Technical Bulletin SWEM20-001R2-TB

Subject: How to replace OLED in ICP panel

SWEM20-001R2-TB

We will release a new OLED with a longer life in conjunction with the current discontinued product. This technical memo describes how to replace the old OLED.

KY-688 A Side

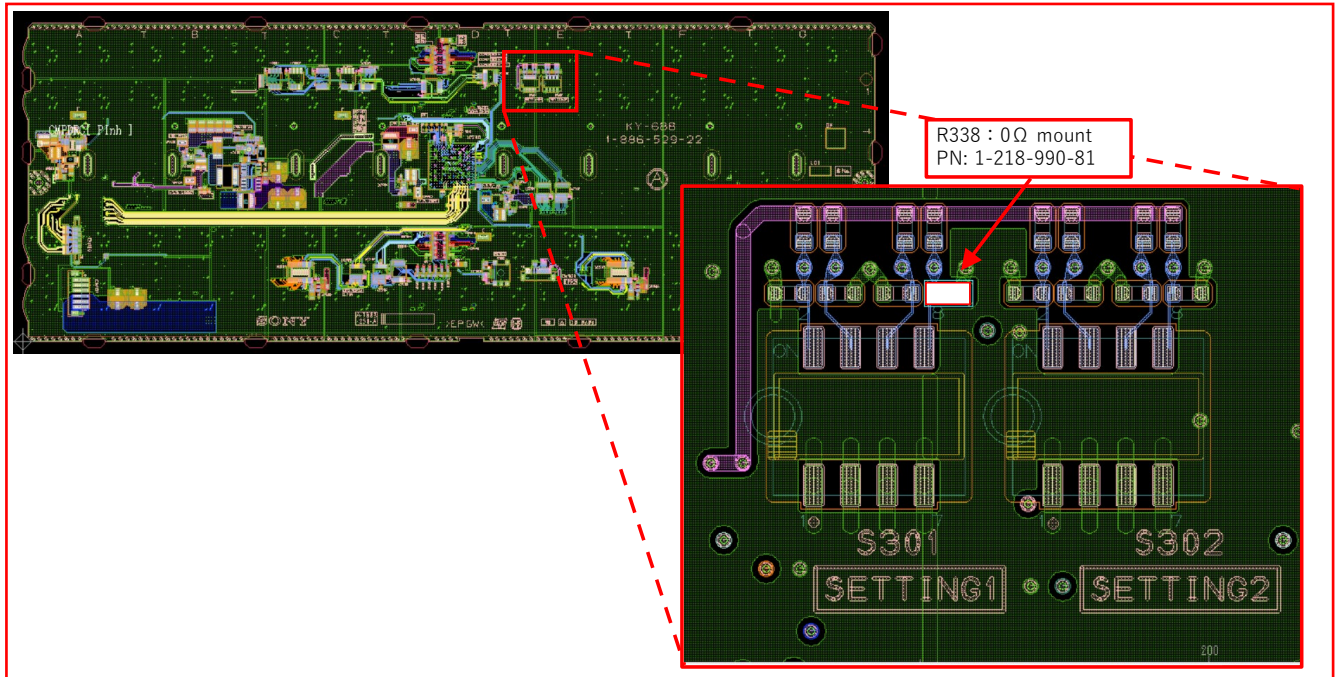
For areas A, D and G: KY-688

- Mount a 0Ω register on R323. (Set FPGA to new 2.7inch OLED mode.)

KY-689 A Side

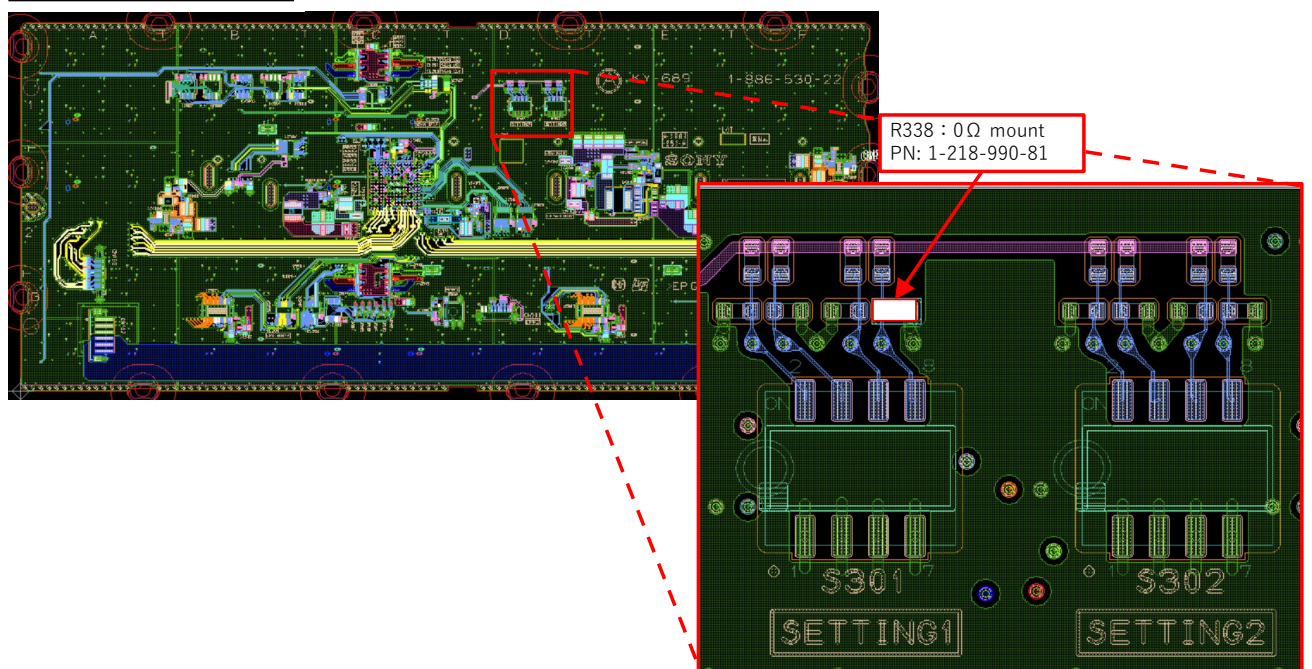
For areas B, E and H: KY-689

- Mount a 0Ω register on R338. (Set FPGA to new 2.7inch OLED mode.)

KY-689 A Side

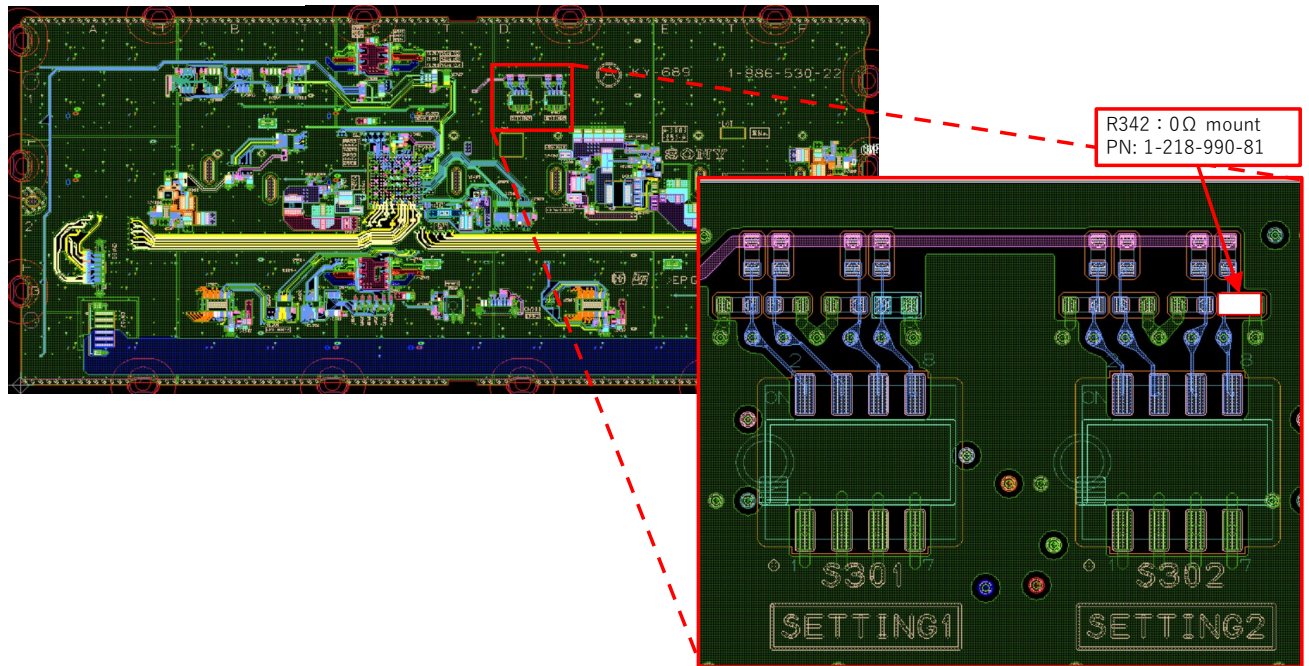
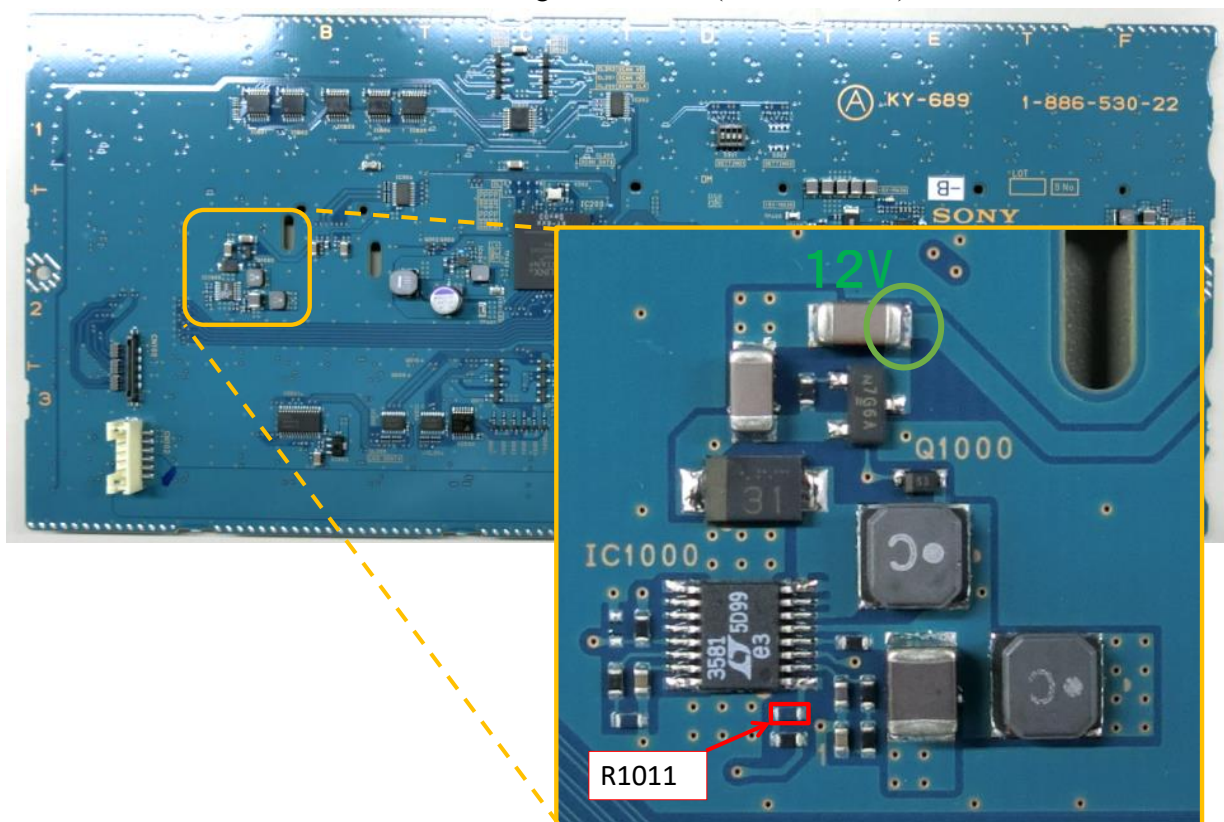
For areas C, F and J: KY-689

- Mount a 0Ω register on R342. (Set FPGA to new 0.8inch OLED mode.)

- Remove R1011 and mount a $30k\Omega$ register instead. ($10.4V \Rightarrow 12.0V$)

*If the repair is done correctly, the green part shows the voltage of 12V.

KY-699 A Side

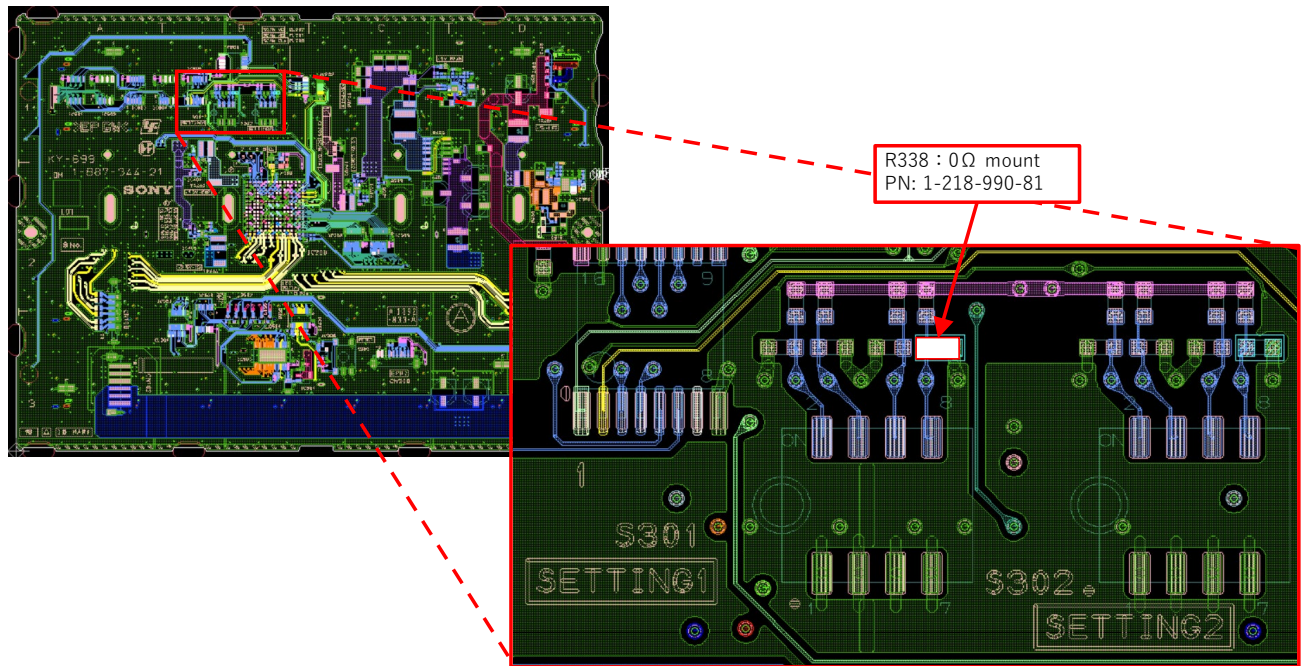
For areas K and L: KY-699

- Mount a 0Ω register on R338. (Set FPGA to new 2.7 inch OLED mode.)

KY-690 A Side

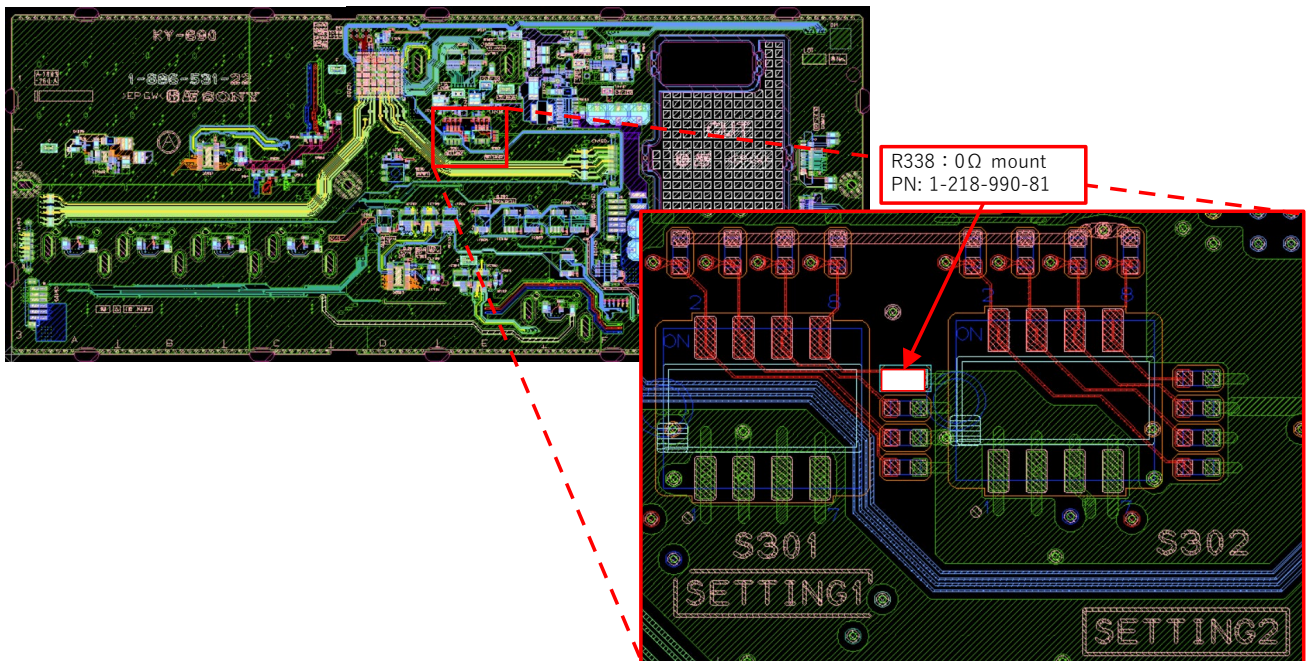
For area M: KY-690

- Mount a 0Ω register on R338. (Set FPGA to new 2.7 inch OLED mode.)

KY-690 A Side

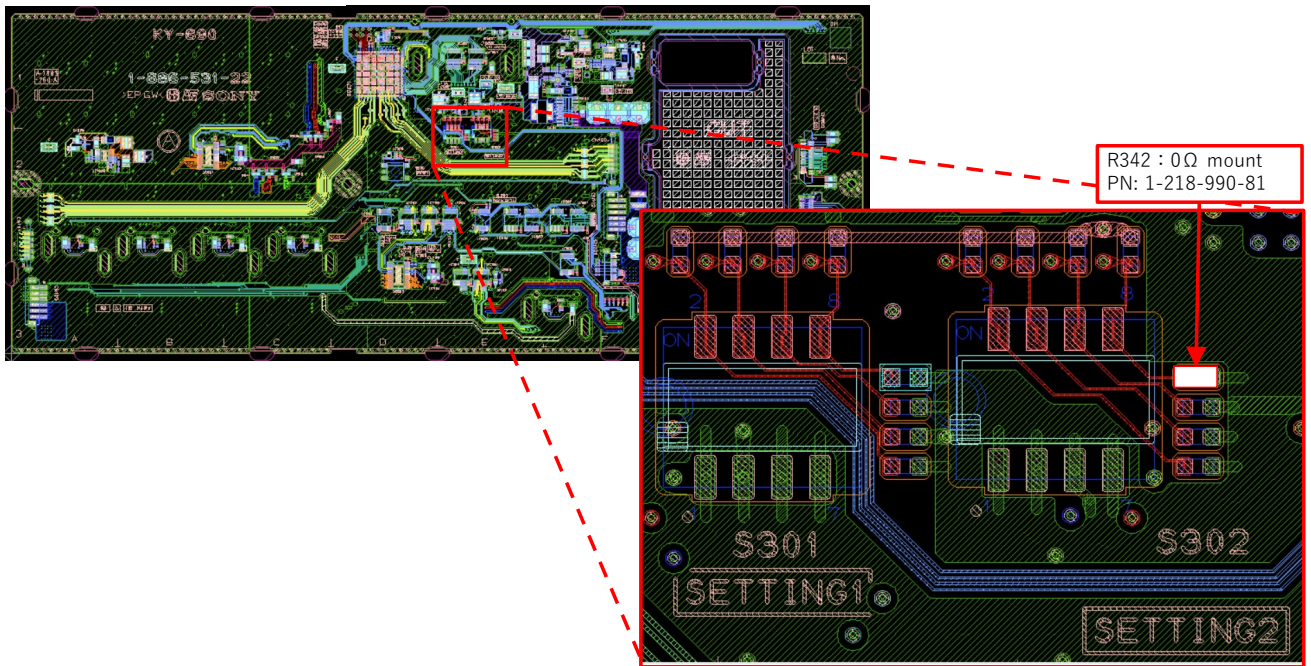
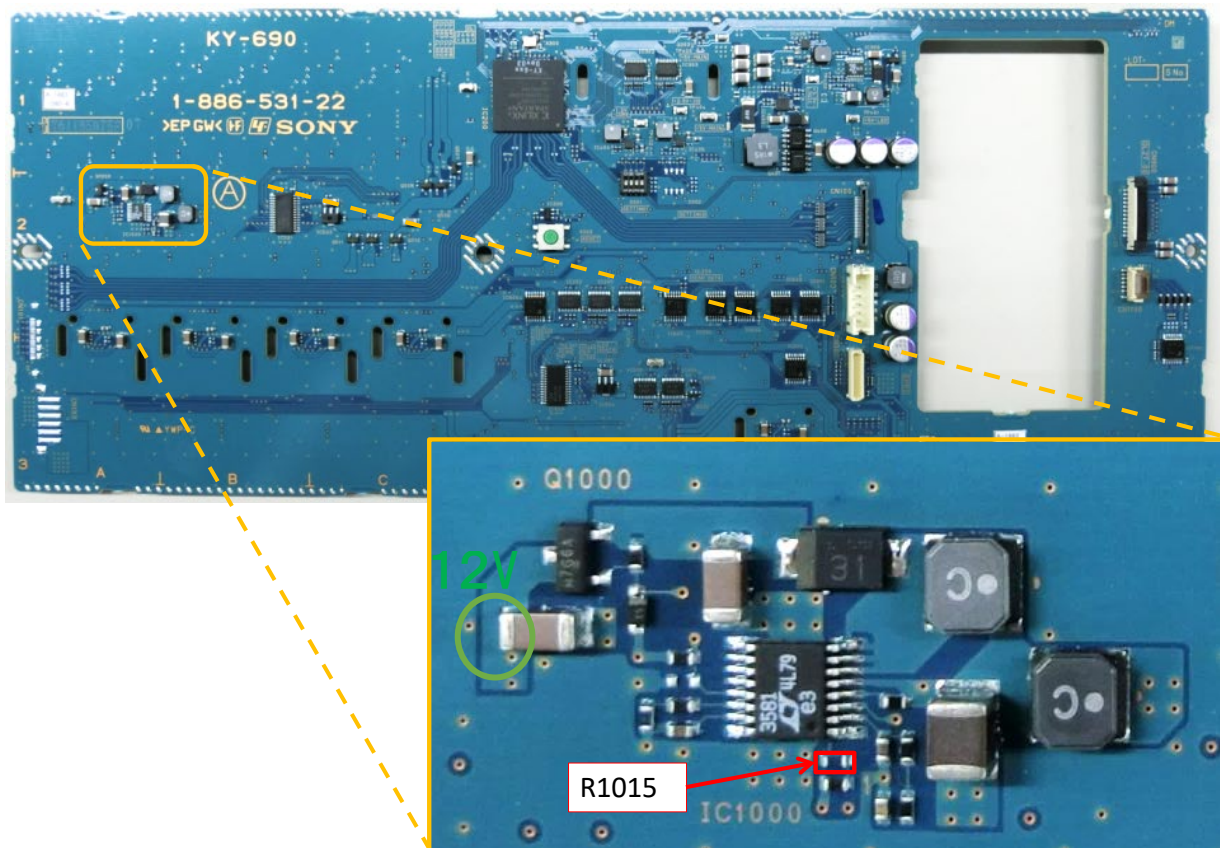
For area N: KY-690

- Mount a 0Ω register on R342. (Set FPGA to new 0.8 inch OLED.)

- Remove R1015, Mount a $30k\Omega$ register instead. ($10.4V \Rightarrow 12.0V$)

*If the repair is done correctly, the green part shows the voltage of 12V.

KY-691 B Side

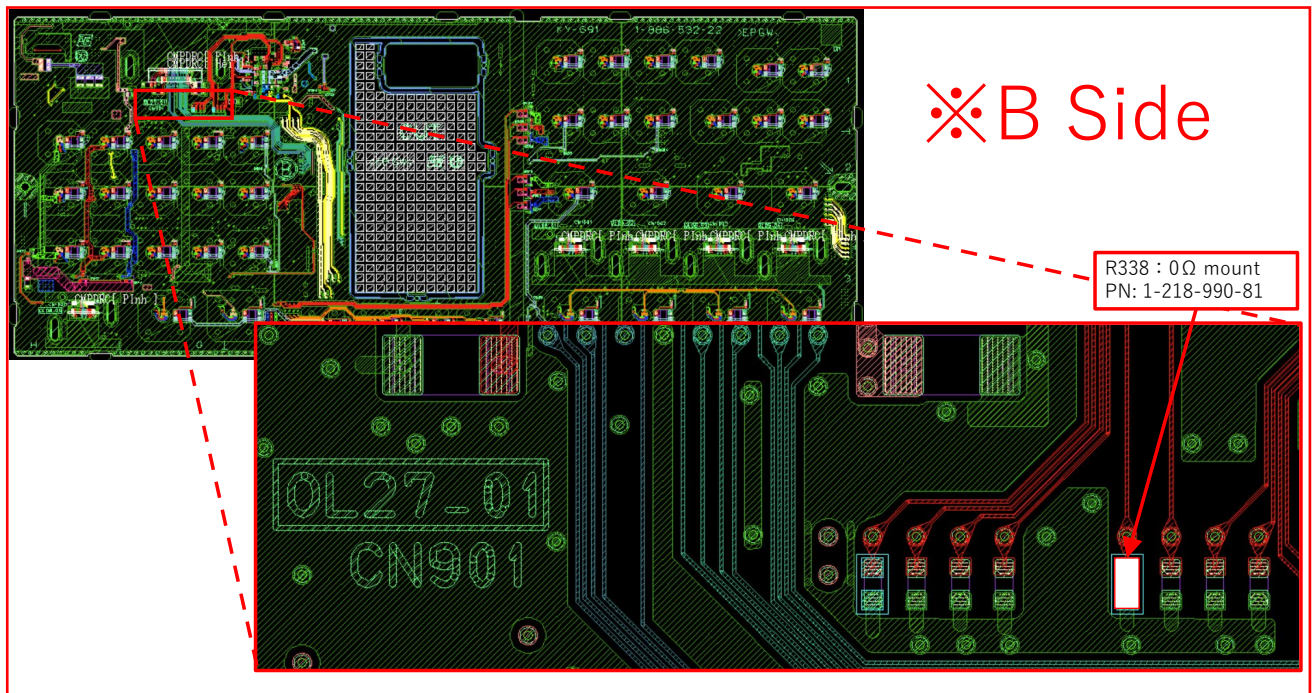
For area P: KY-691

- Mount a 0Ω register on R338. (Set FPGA to new 2.7 inch OLED mode.)

KY-691 B Side

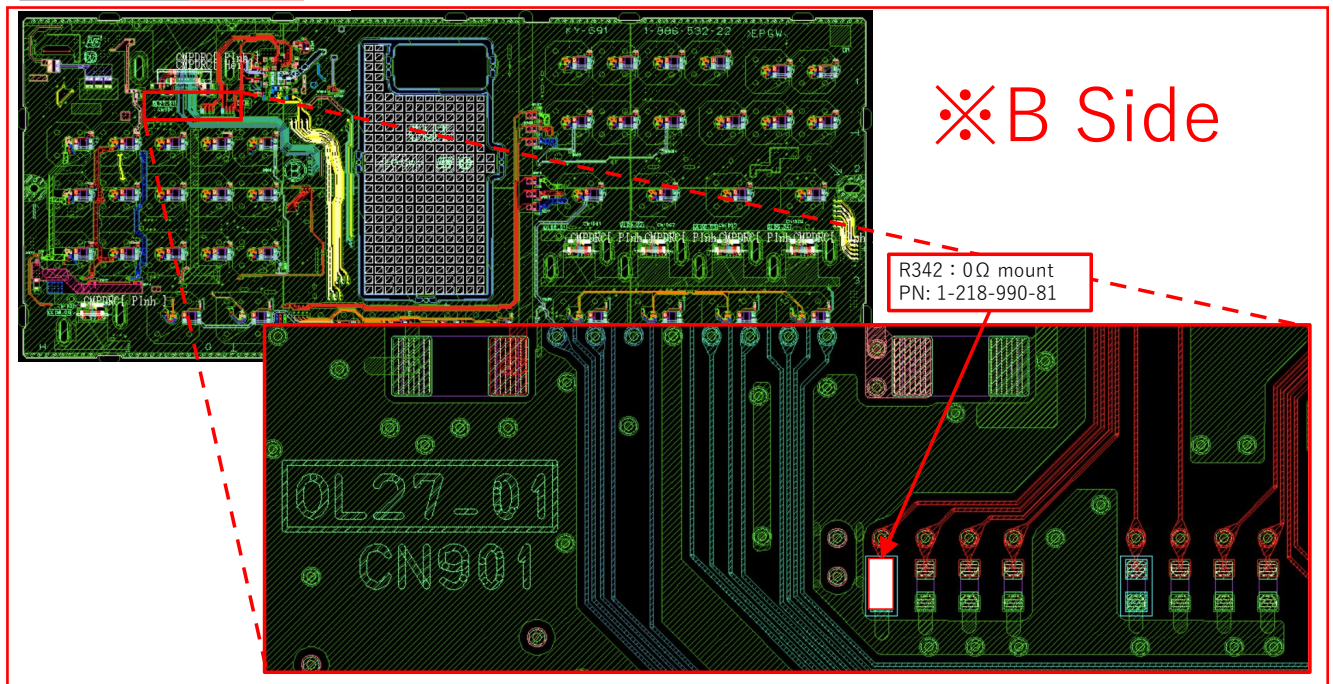
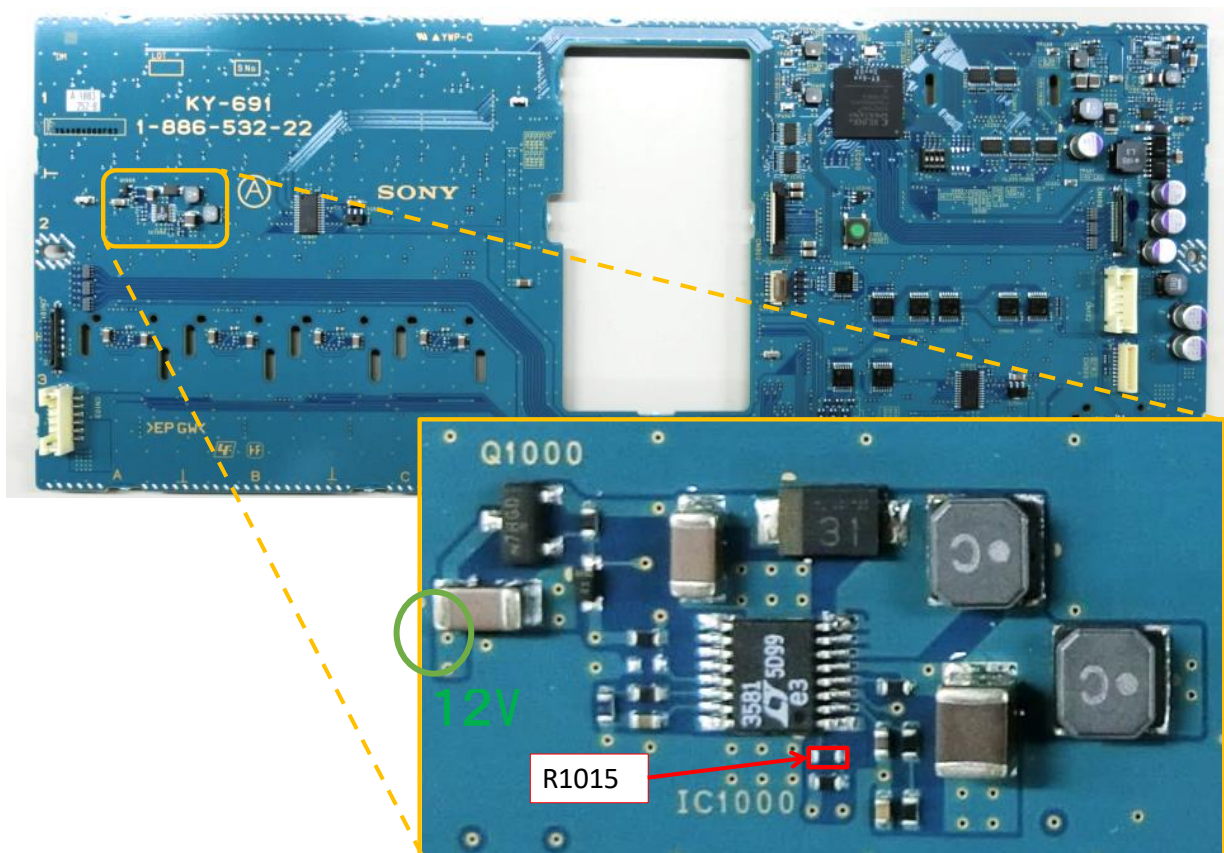
For area Q: KY-691

- Mount a 0Ω register on R342. (Set FPGA to new 0.8 inch OLED mode.)

- Remove R1015 and mount a $30k\Omega$ register instead. ($10.4V \Rightarrow 12.0V$)

*If the repair is done correctly, the green part shows the voltage of 12V.

KY-692 A Side

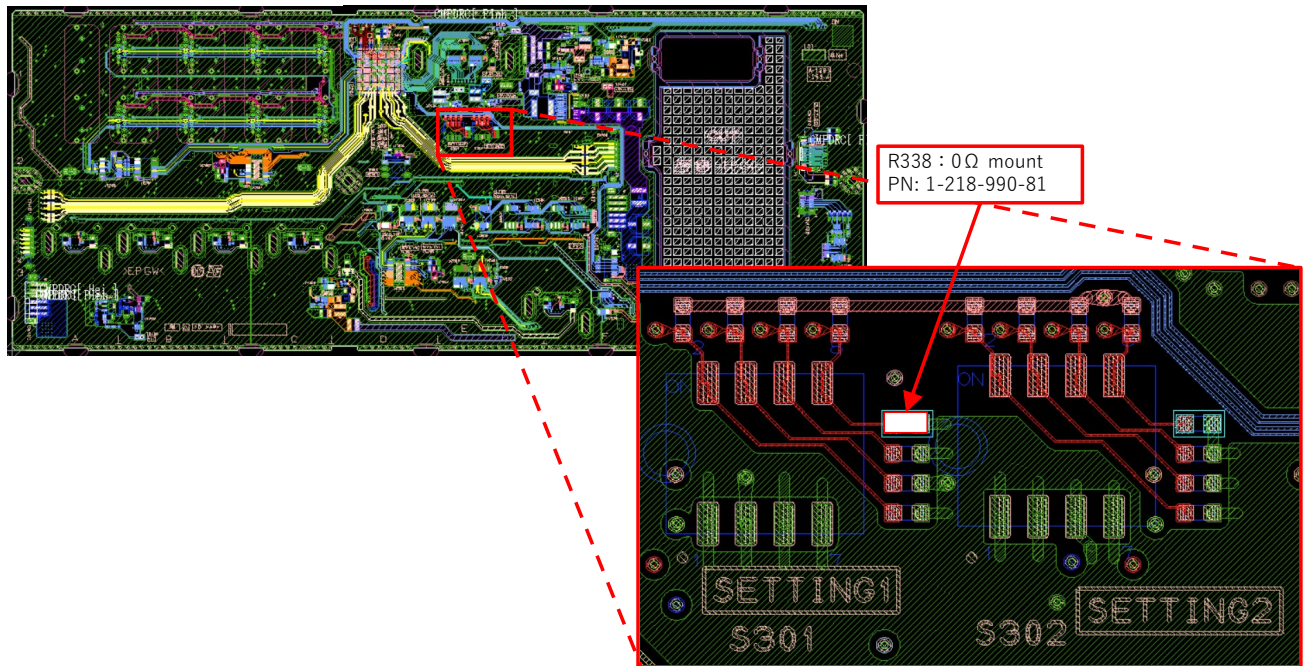
For area R: KY-692

- Mount a 0Ω register at R338. (Set FPGA to new 2.7 inch OLED mode.)
